MISSISSIPPI RIVER - GULF OUTLET  
LOUISIANA

-----  
DESIGN MEMORANDUM NO. 1-C

CHANNELS

ENGCW-E(7 Apr 61) 2nd Ind  
SUBJECT: Revisions to Design Memorandum No. 1-C, Mississippi River-  
Gulf Outlet

STA. 3560+00 TO STA. 3760+00  
SCALES AS SHOWN  
U. S. ARMY ENGINEER DISTRICT, NEW ORLEANS  
CORPS OF ENGINEERS

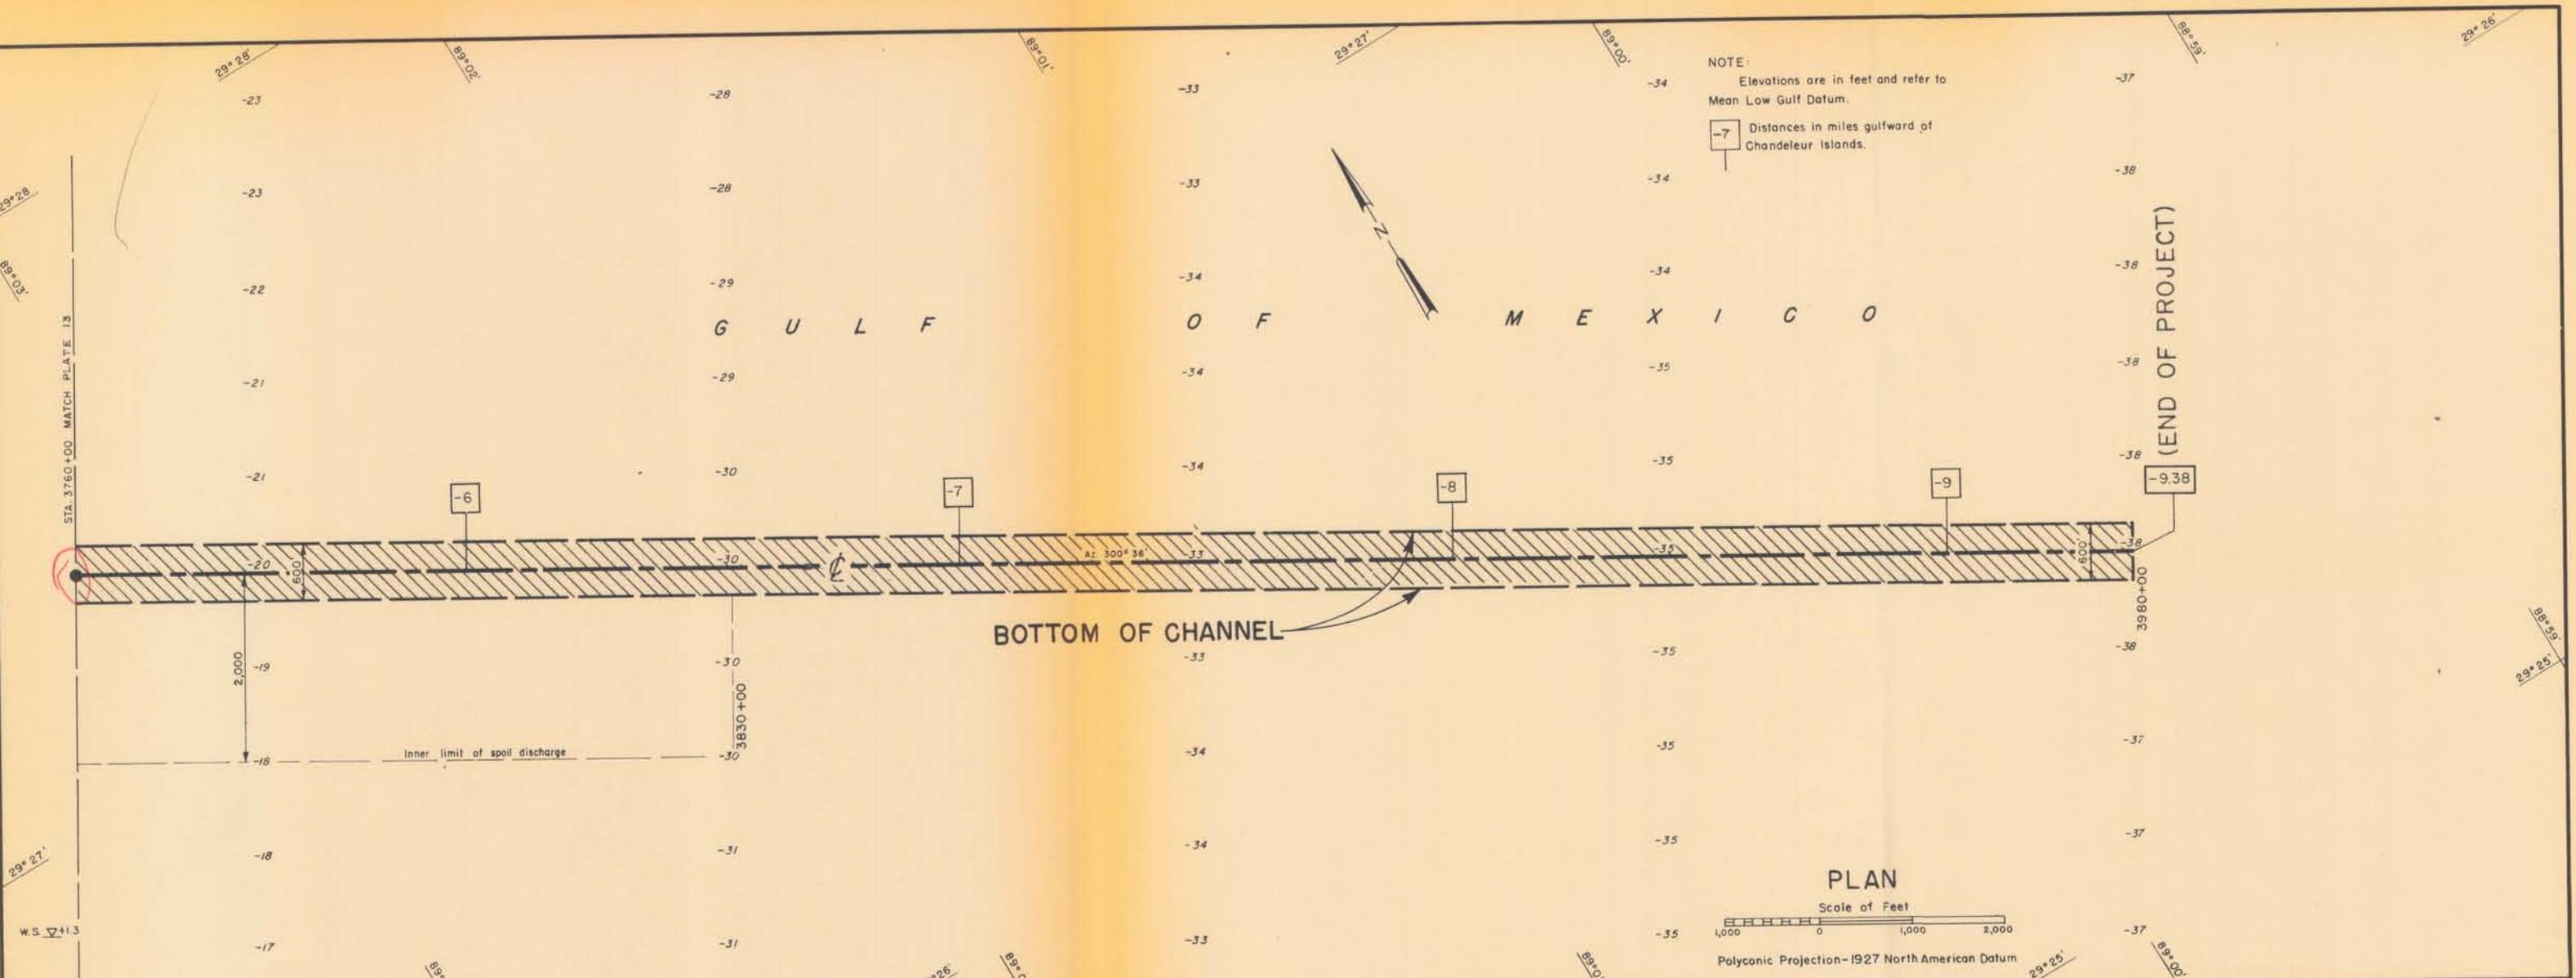
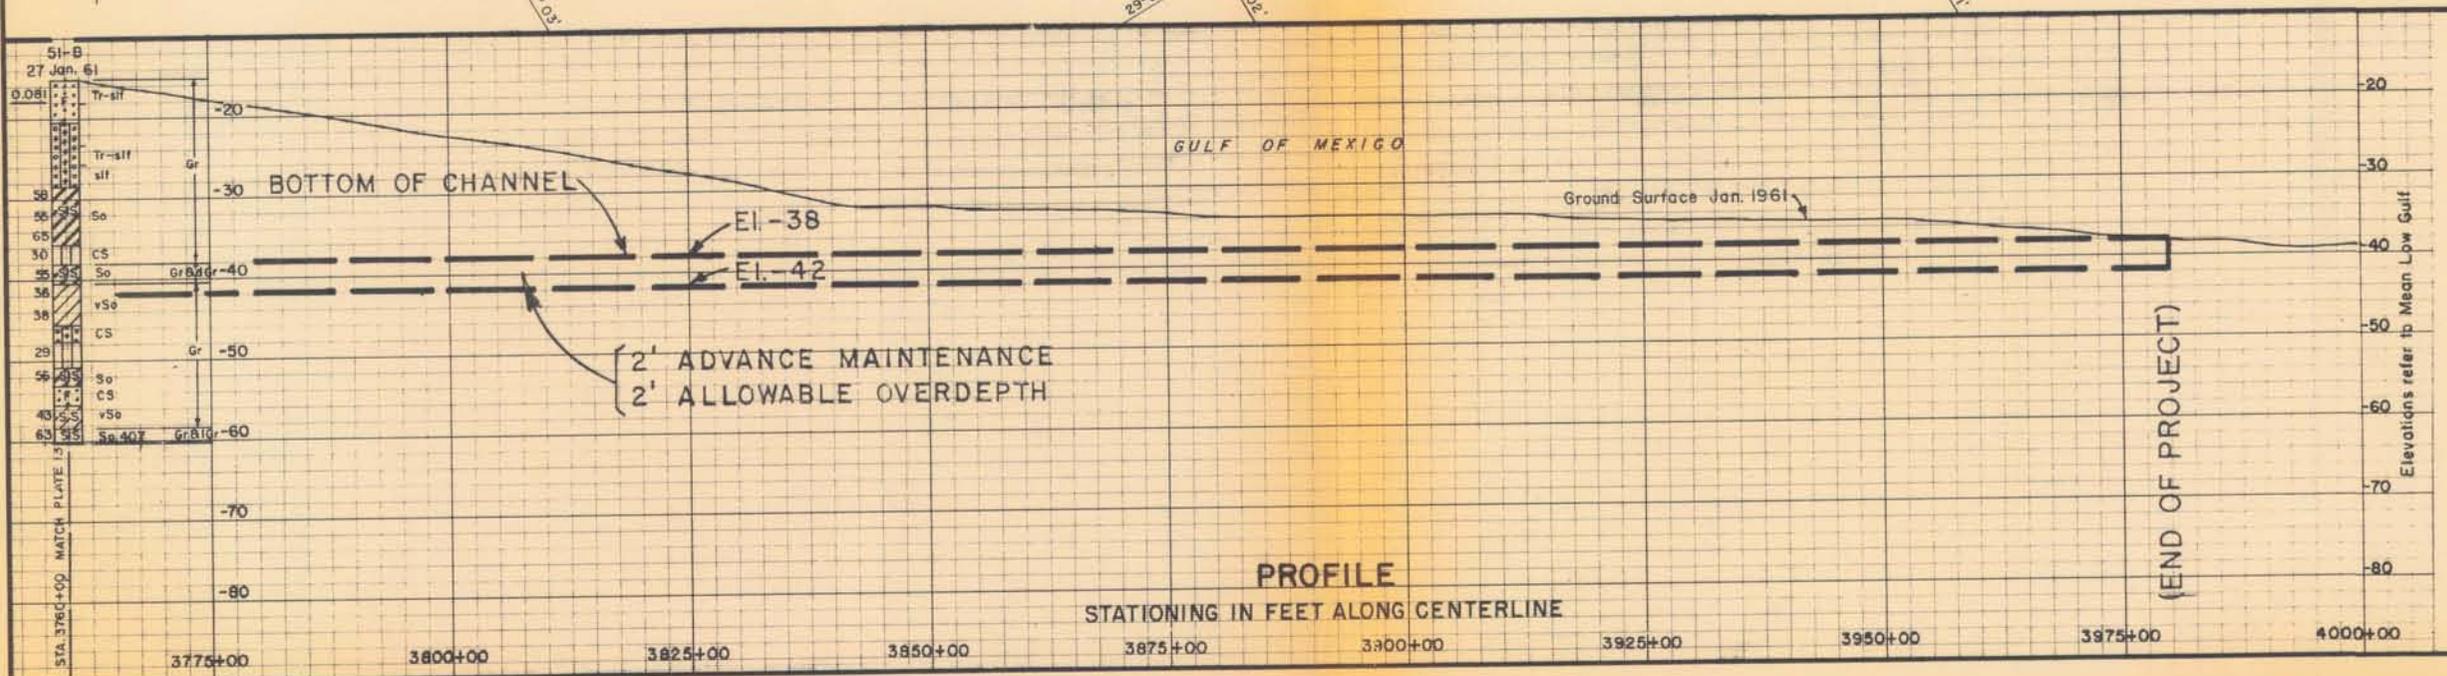
5. On plate 14, it is noted that the inner limit of the spoil disposal area paralleling the channel extends through the reach of channel to be constructed by a hopper dredge. Since the hopper dredge will dump in the Gulf of Mexico in depths of over 50 ft. this limit is without significance.

h. Plates 12 through 14. Add the following footnote:  
"The alignment beyond Station 3484+80 will be determined from detailed surveys taking into consideration the preference of ship operators for an angular or straight channel alignment with respect to the channel across Breton Sound."

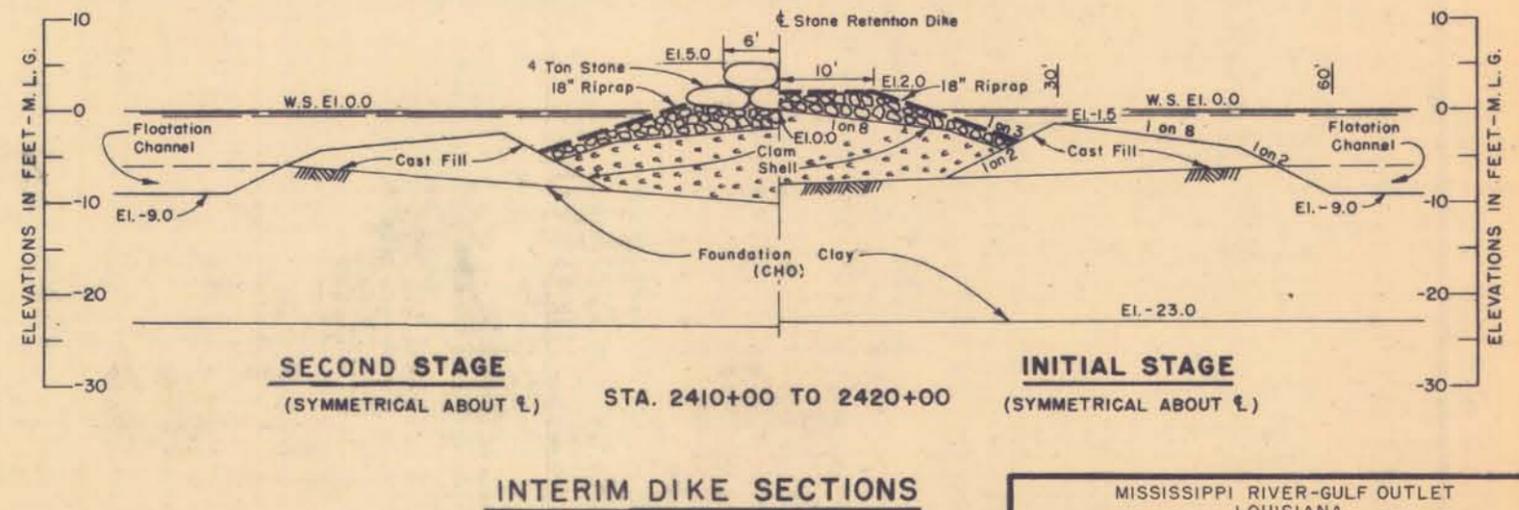
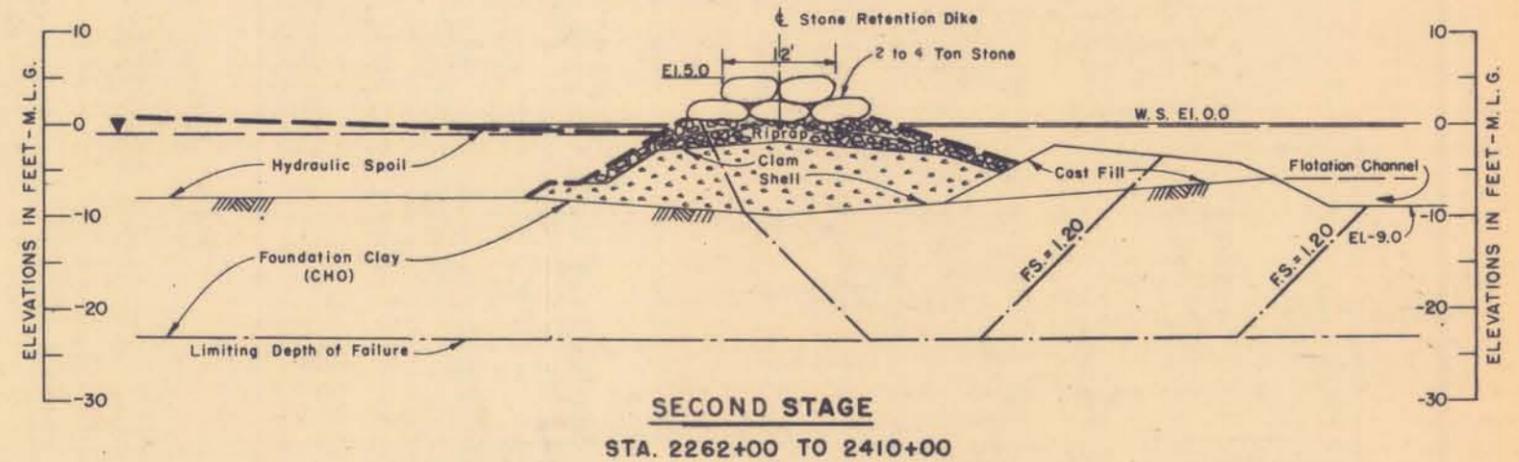
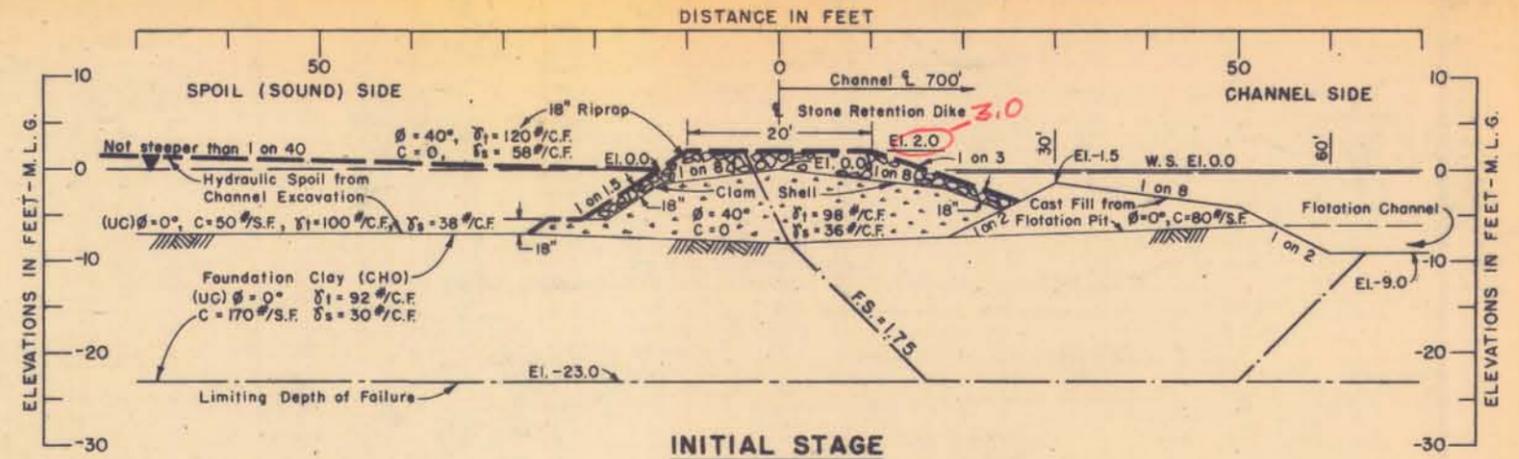
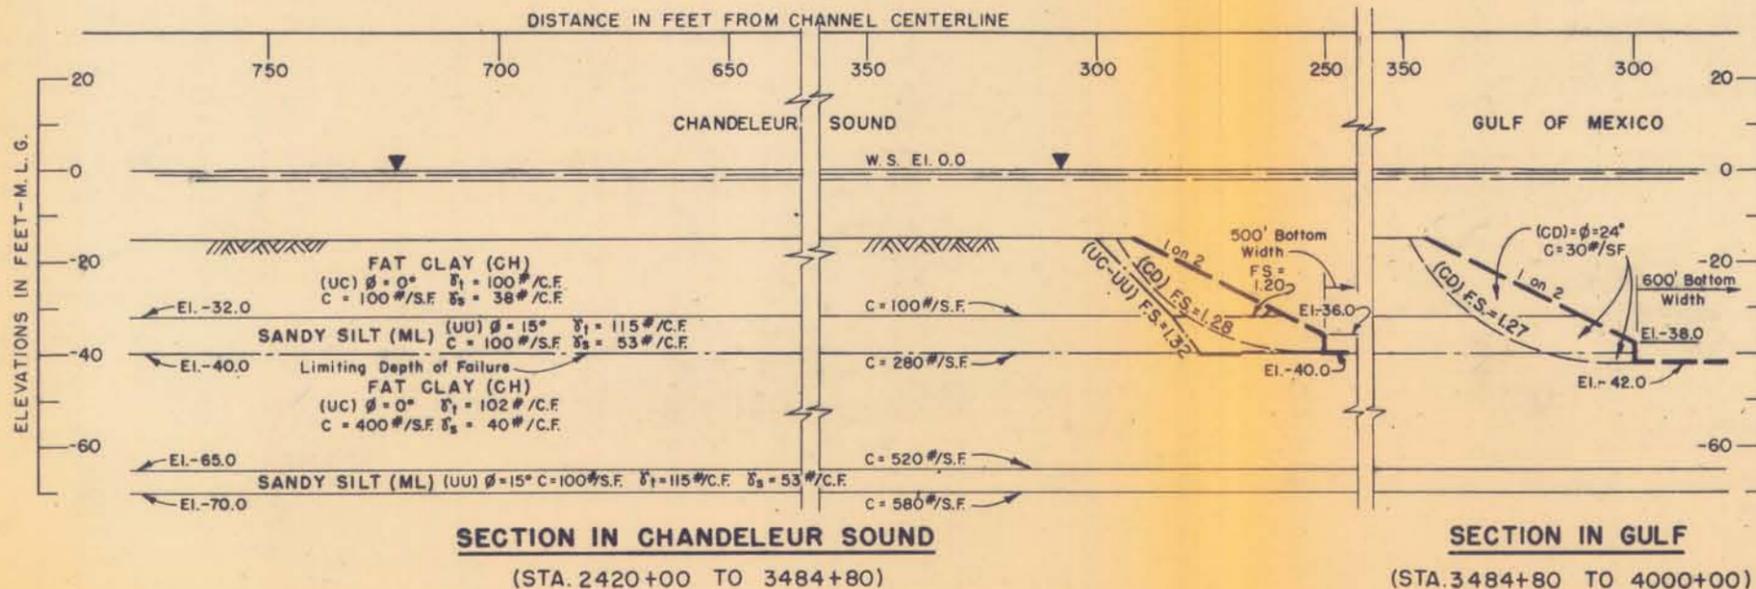
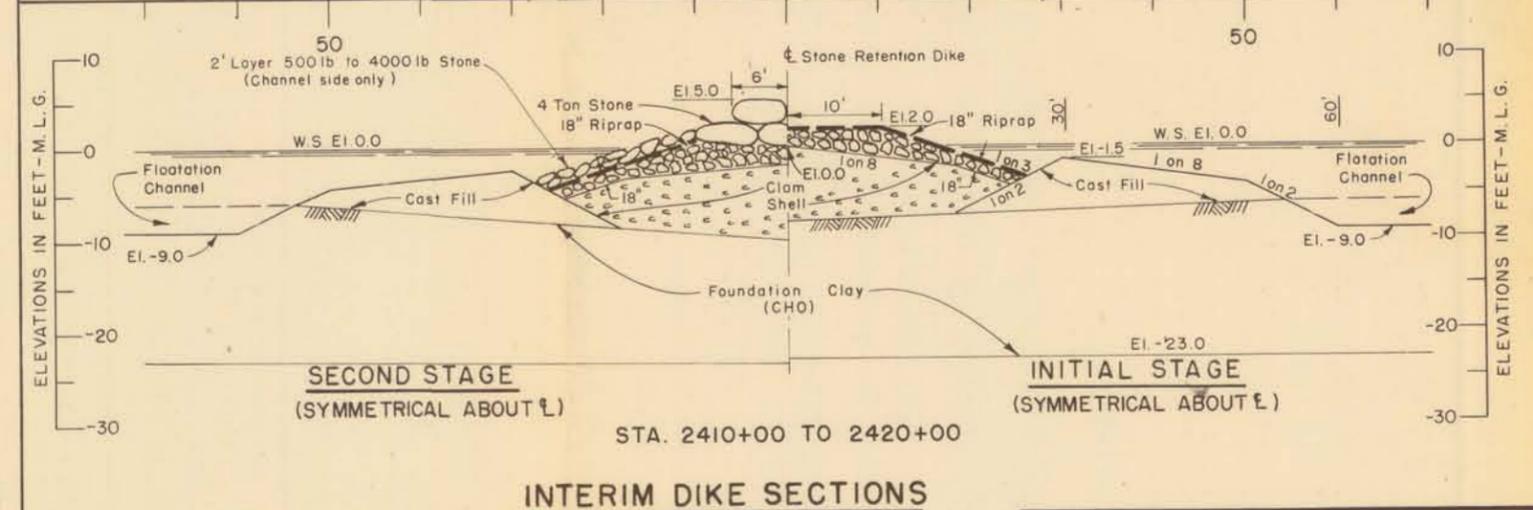
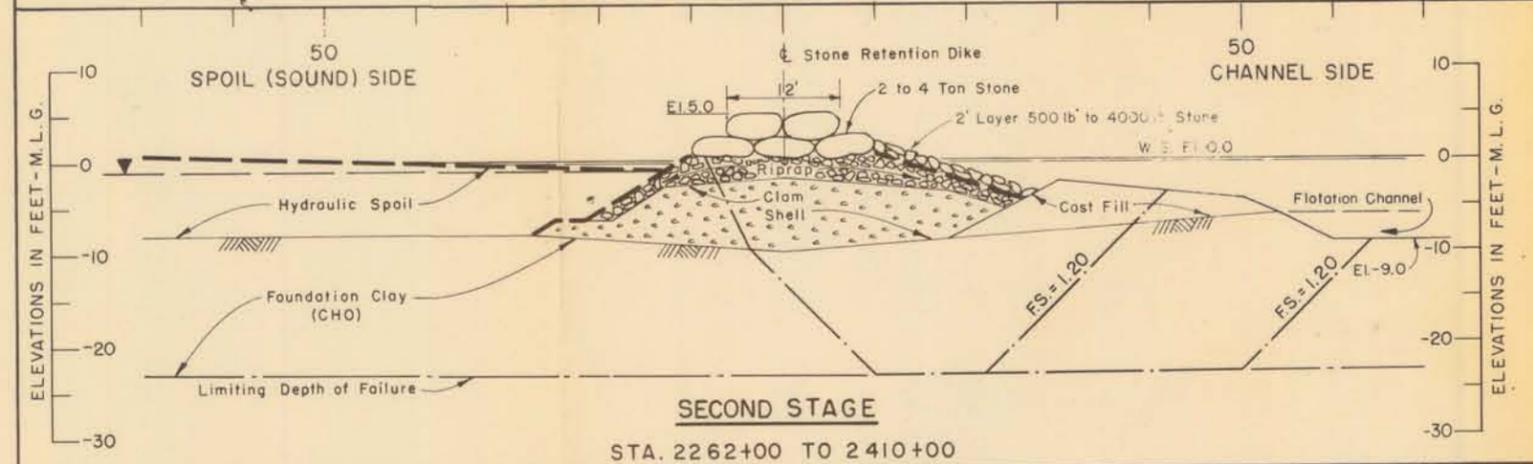
2. Reference is made to the dike cross-section described in revised DM paragraph 18 and shown on revised Plate 16. The planned dike section consists of shell core with 18 inches of riprap (of undefined size) along the sides and top, and a cap of 2-4 ton stone. If protection for that part of the dike in the greater depths is not extended over the entire area exposed to wave forces (to one wave height below still water elevation) there is a danger of the small stone being removed from beneath the crest stone with subsequent subsidence of the cap. However, if this part of the dike settles a minimum of 2 feet, there-after the riprap would be in a relatively safe depth of water. Maintenance estimates should include a contingency item to cover the cost of some additional replacement of stone due to storm damage during the early life of the project.

3. The references to "a 5 ft. crown at elevation +5.0 ft. mlg" in paragraphs 6b and 18 appear to be in conflict with the detail on plate 16. Clarification is requested.

c. Par 6b, page 3. Analyses of dikes on Plate 16 show that side slopes of 1 on 3 instead of 1 on 1.5 are required for the channelside portion of the rock dike.

i. Plate 16. (1) It is understood that the limiting depths of failure shown were determined by analyses and that failure planes deeper than those shown had higher factors of safety.

(2) The factor of safety of the 1 on 1.5 spoil side dike slope should be reported. It is understood that this factor of safety was found to be adequate.

(3) Computations for the most critical failure surface should be included in accordance with EM 1110-2-1805 of 15 October 1958.

3. The dike is designed to have an ultimate crown width of 5 ft. after settlement. Since it is estimated that settlement will not be completed during the project construction period, the final capping will be performed as an item of deferred construction. It is estimated that 7 to 10 years will be required for settlement to take place after the initial placement of the capping stone and that the deferred capping will cost \$267,000.
